STAFF REPORT FOR THE HISTORIC REVIEW BOARD

FILE NUMBER: DR-15-05

REQUEST: Class II Historic Design Review - Removal of an addition and rebuild of original turret on front of house, to build an addition on rear of house, and convert the non-contributing carport into a two-story garage

Proposed Plot Plan

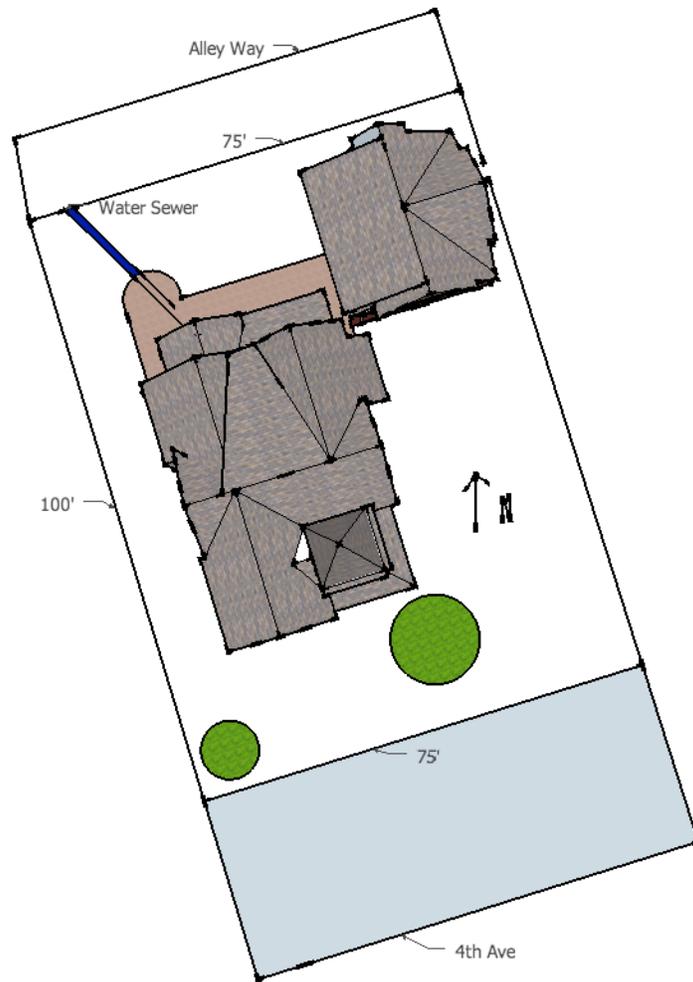
Staff Finding 24: The proposed detached accessory structure is located in the rear yard and shall meet the setback requirements of CDC 25.070(C) 1-4 (see Staff Findings 29-32). The proposal is for a two-story garage and the applicant is requesting a modification to reduce the required 10 foot setback from the house to a three foot setback. The proposal indicates an 11-foot setback from the rear property

line and the minimum required for the rear is three feet. The required 10 foot setback from the house can be accommodated and is recommended as Condition 1 of the approval. These criteria are met.

Staff Finding 32: The proposed rear addition to the home meets the 20 foot setback. The proposed accessory structure is located 11 feet from the rear property line but to comply with Condition 1 of the approval, the proposed accessory structure will need moved closer to the rear property line and maintain the three foot minimum setback. This criterion is met.

1. Two-story garage setback. The accessory structure shall conform to the required 10-foot setback from the house and maintain a minimum three foot setback, including eaves, from the rear property line.
